Project:
 Extension and Alterations
 Riverwood Cottage, Stoneygroves Liff

Extg Site Plan

Dwg No:
 202210_EX_90_001

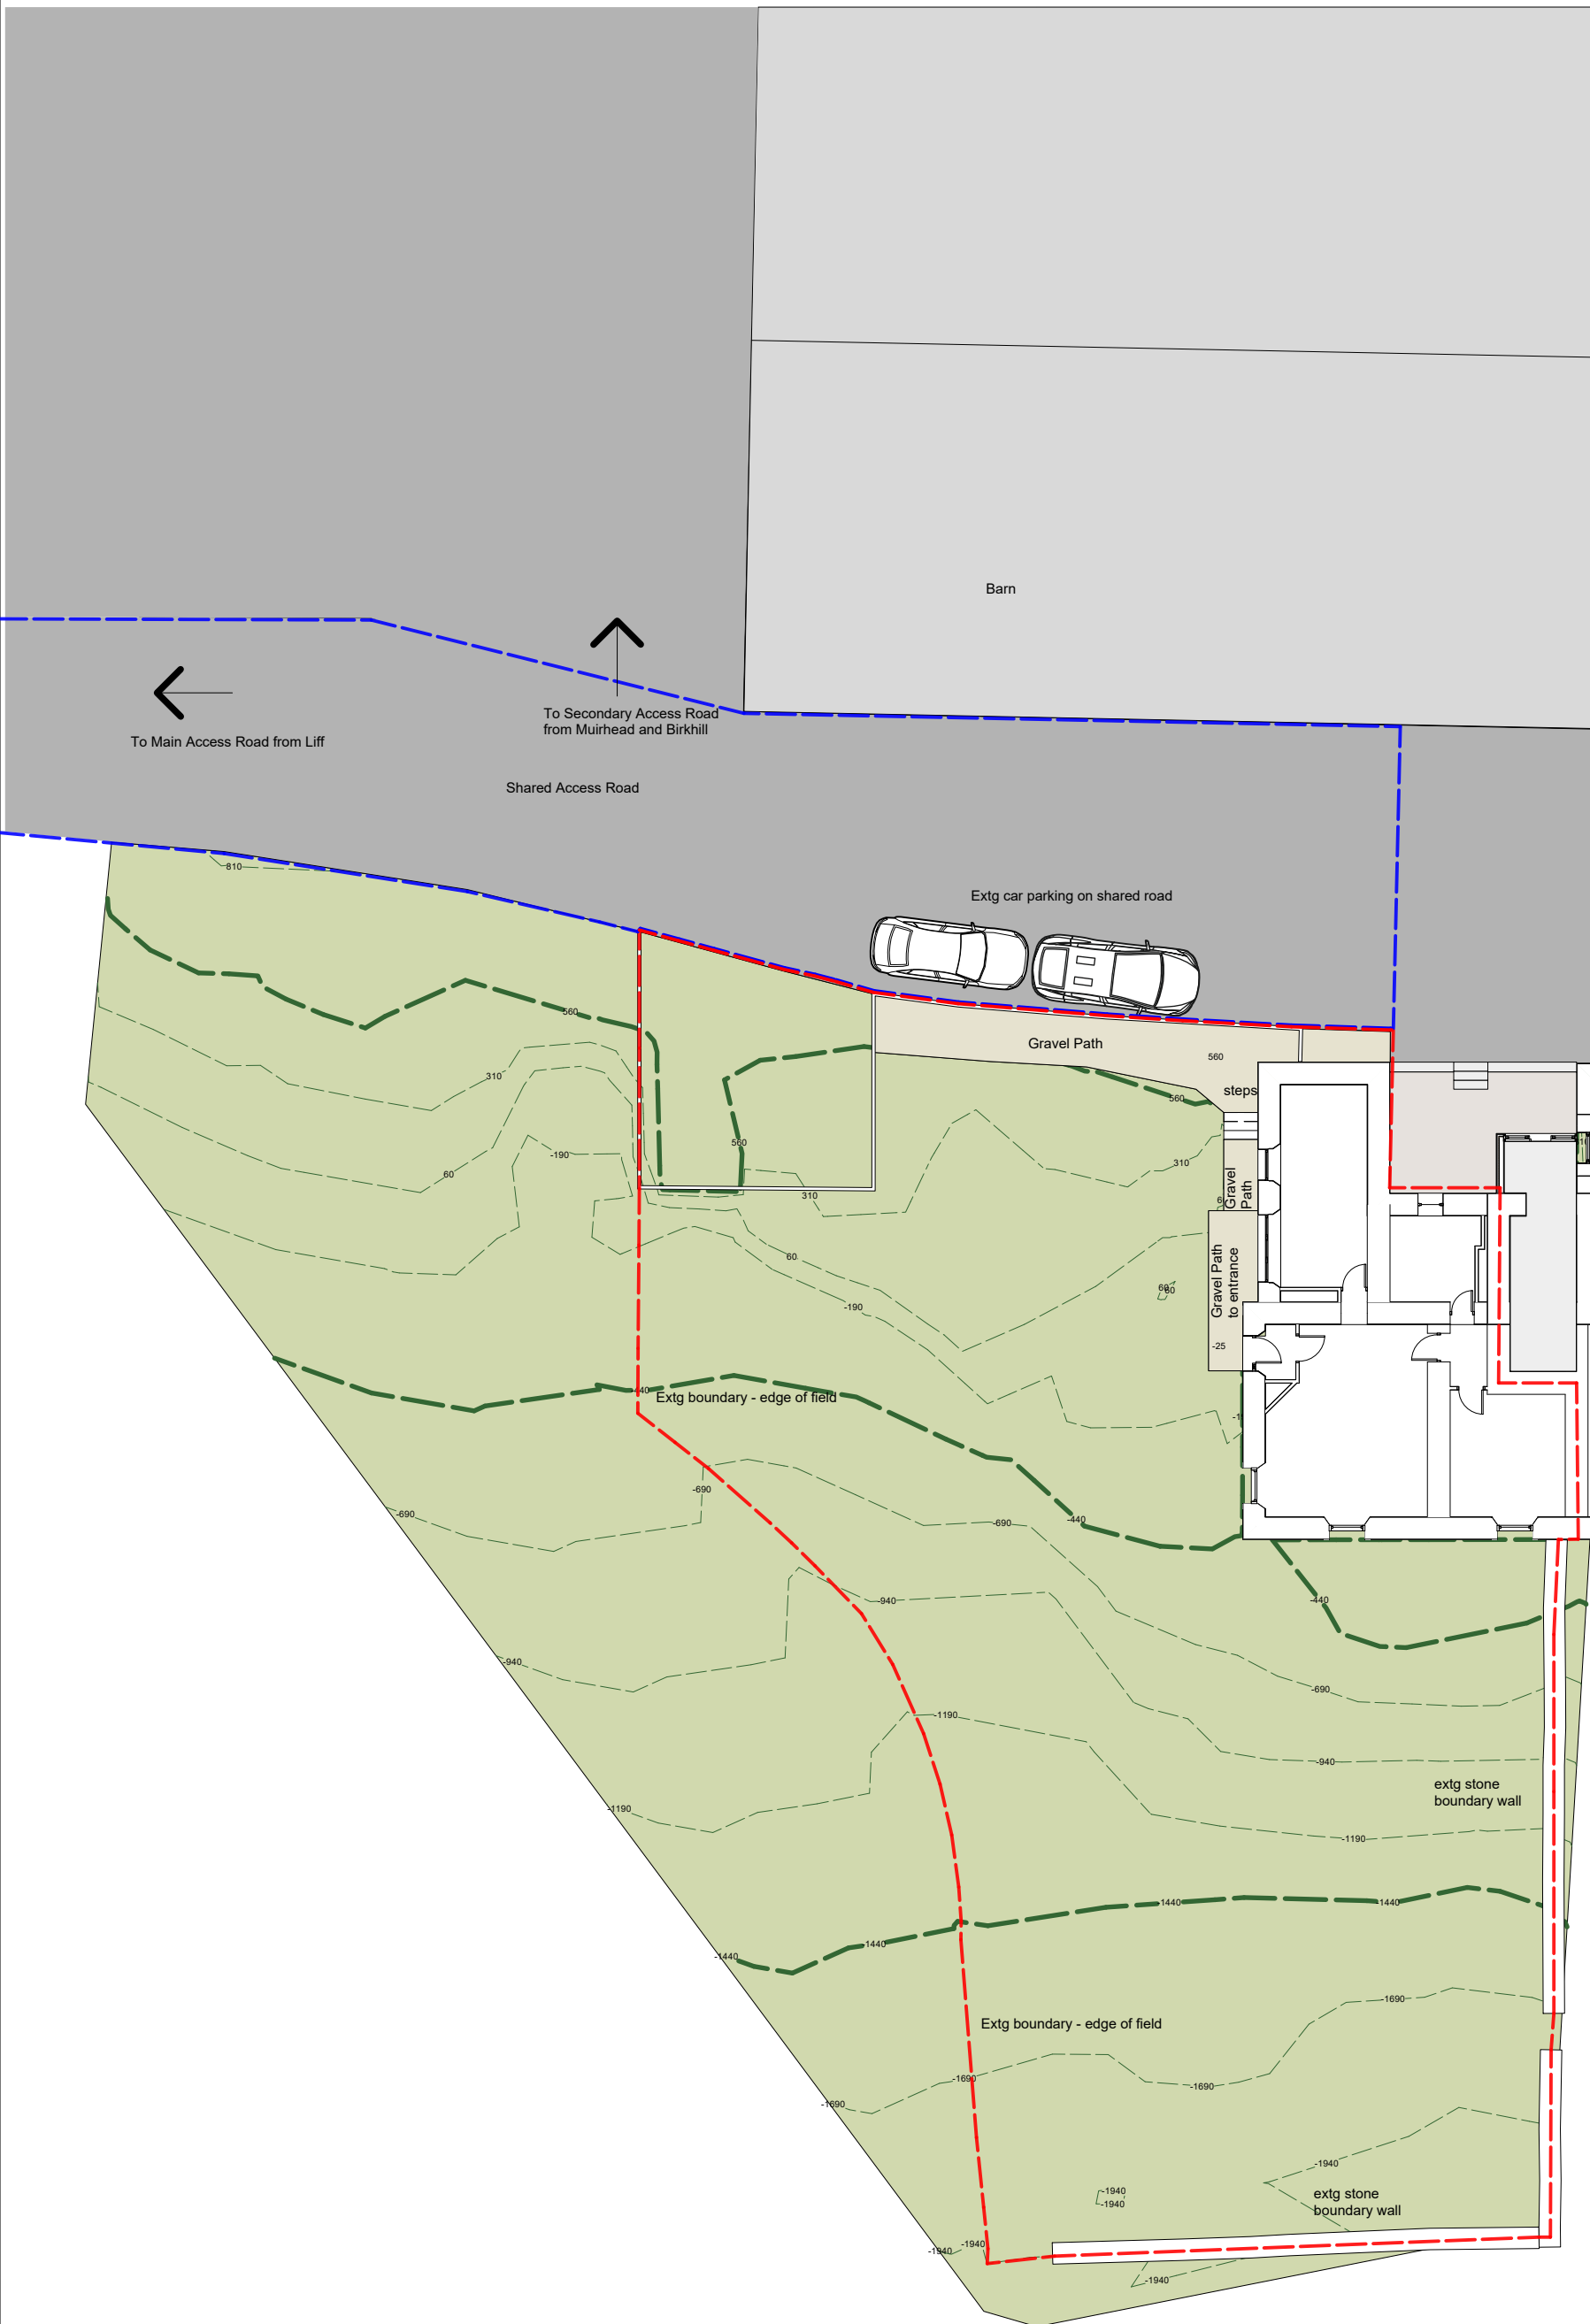
A - 02/11/23
 Red and blue line boundaries revised as requested by Angus Council.
